Brisbane Road Car Park Redevelopment

Independent Assessment Report on Noise Aspects of Application

Report: 9001R06V01.docx

Sunshine Coast Council

Figure 1.2 Ground Floor Plan of Development (Drawing 10630 DA11 Issue 8)

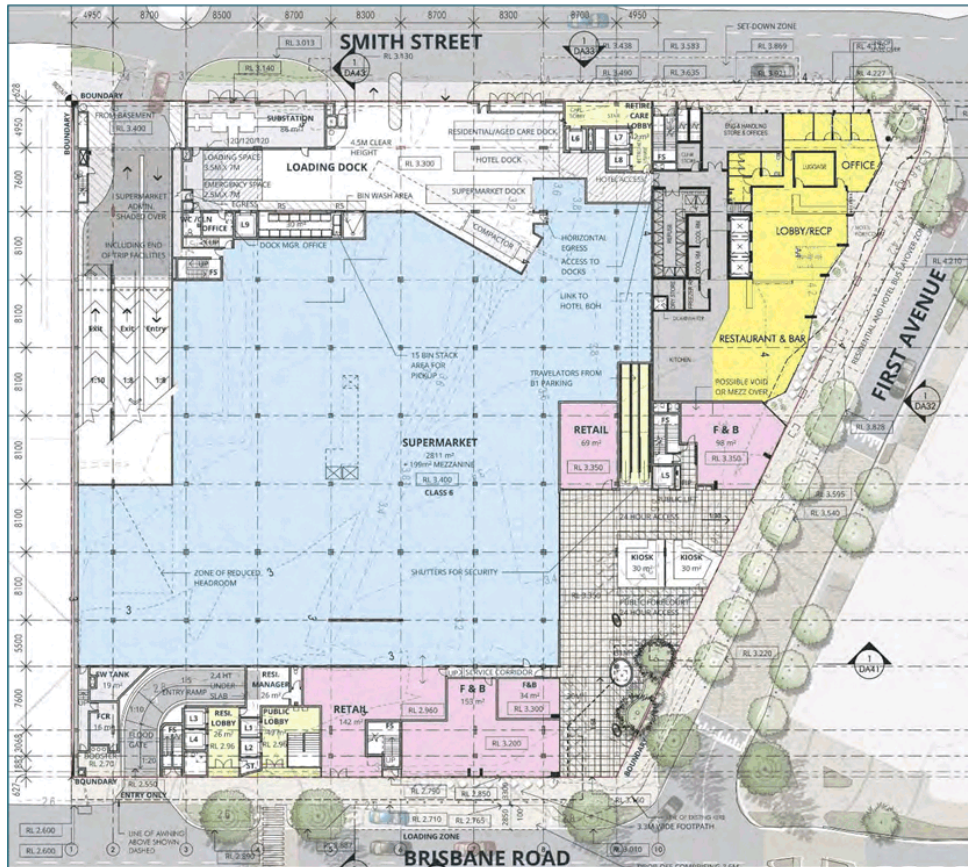
The development plans show that the loading dock including waste storage collection is at ground level off Smith Street to the west, at the back of the supermarket in the retirement building. This is evident toward the top of

Section 4.3 of the MWA report includes an assessment of loading dock noise. The results in Table 13 indicate compliance in the day and evening, but non compliance at night, and hence proposes hours of 7am to 10pm which should be conditioned. The assessment does not make reference to refrigerated vehicles, and hence a revised assessment is required which considers refrigerated vehicles else they be restricted to daytime hours (7am to 6pm) Monday to Saturday. The report proposes an absorptive ceiling which should be conditioned.

- (4) The loading dock is to be restricted to the following hours:
 - (a) Non-refrigerated vehicles: Daytime and evening hours of 7am to 10pm Monday to Saturday, and 7am to 6pm Sunday;

- (b) Refrigerated vehicles: Daytime hours of 7am to 6pm from Monday to Saturday, unless an updated noise report which demonstrates compliance in other periods is submitted; and

- (c) Refuse collection: Daytime hours of 7am to 6pm from Monday to Saturday.
- (5) The loading dock is to include acoustic absorptive treatments which are to be evenly distributed across the loading dock area, ideally on the soffit. The acoustic absorptive treatments are to have a minimum Noise Reduction Coefficient of NRC 0.5 and a total area equivalent of at least 60% of the soffit area of the total loading dock area.
